**Staff Report: Century XXI
 Preliminary Plan 120070650
 Site Plan 820070150**

MCPB HEARING

DESCRIPTION: Creation of one lot for the construction of 235,000 gross square feet of general office use, on 11.53 acres in the I-3 Zone; located on Century Boulevard, 1,000 feet east of Aircraft Drive, in the Germantown Master Plan area.

APPENDIX B: Century Boulevard Right-of-Way Exhibit

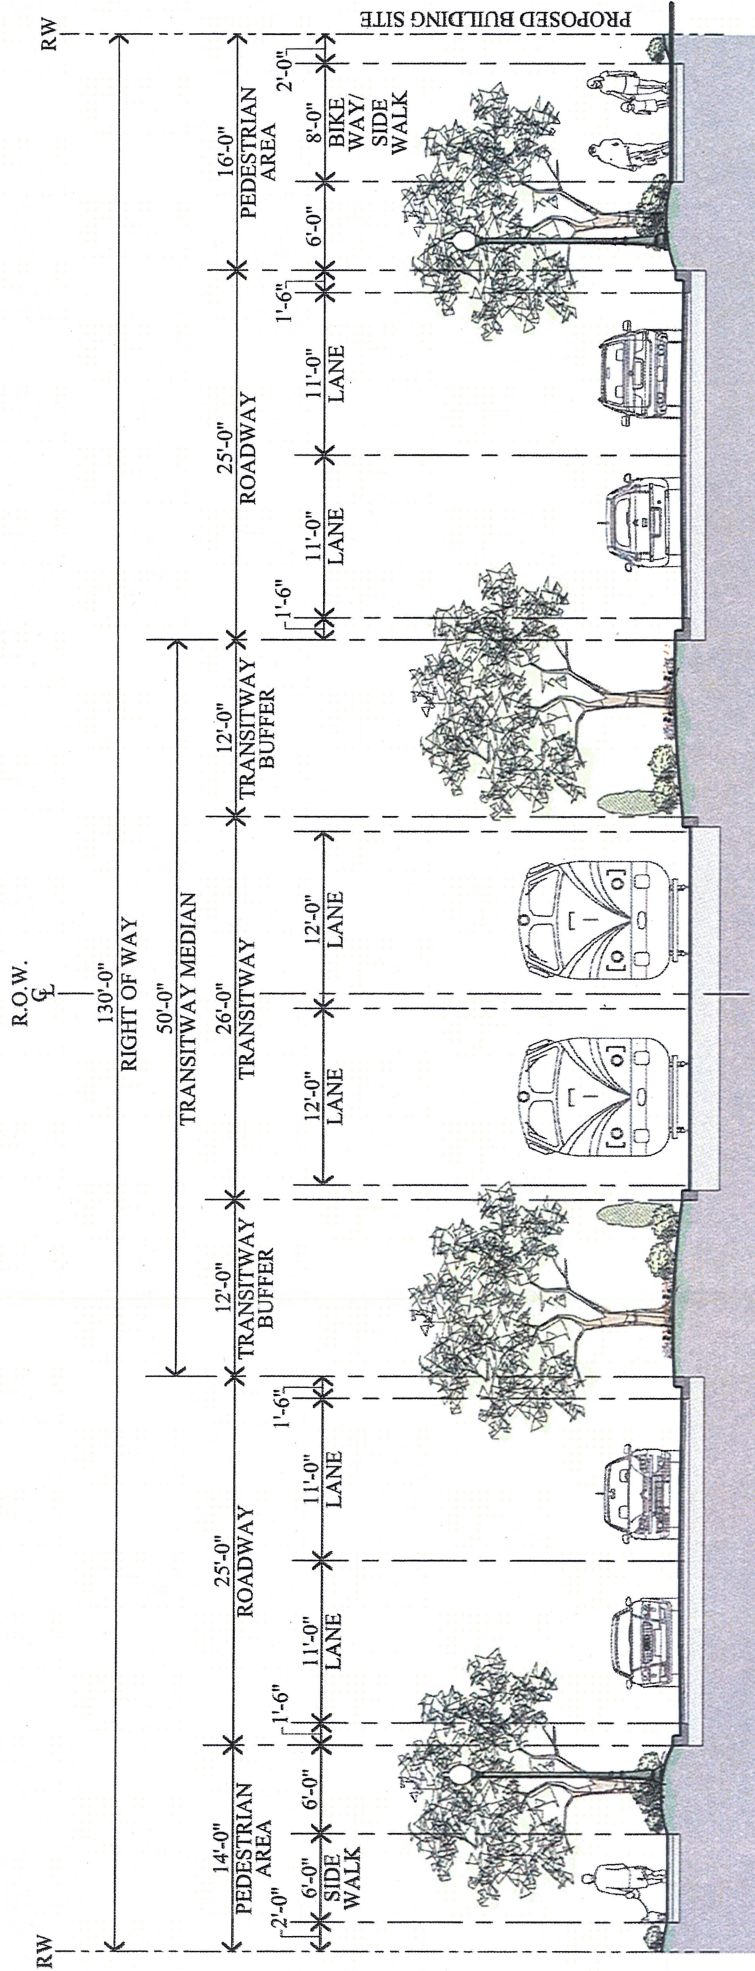
- b. Provide a mix of shade, ornamental, and evergreen trees along the high ground of the property line bordering the I-270 Interchange;
- c. Along the property frontage on the Century Boulevard right-of-way, provide a sidewalk consistent with the exhibit delineating the component elements of the 130-foot right-of-way for Century Boulevard, included as Exhibit B of the staff report. This sidewalk shall comport with the standard Germantown streetscape design. The elements of the revised Century Boulevard include, from the east to west:

- i. a 16-foot pedestrian area: a 2-foot maintenance strip, an 8-foot shared bikeway/sidewalk, and a 6-foot planting strip;
 - ii. a 25-foot roadway: a 1.5-foot curb and gutter, two 11-foot travel lanes, the outside lane of which may be used for parking during off-peak hours, and another 1.5-foot curb and gutter;

- iii. a 50-foot transitway median: a 12-foot transitway buffer, a 26-foot transitway, and another 12-foot transitway buffers;
 - iv. a 25-foot roadway: a 1.5-foot curb and gutter, two 11-foot travel lanes, the outside lane of which may be used for parking during off-peak hours, and another 1.5-foot curb and gutter;

- v. a 14-foot pedestrian area: a 6-foot planting strip; a 6-foot sidewalk; and a 2-foot maintenance strip;
- d. Provide an alternative plant list for substitutions of plant material due to availability;
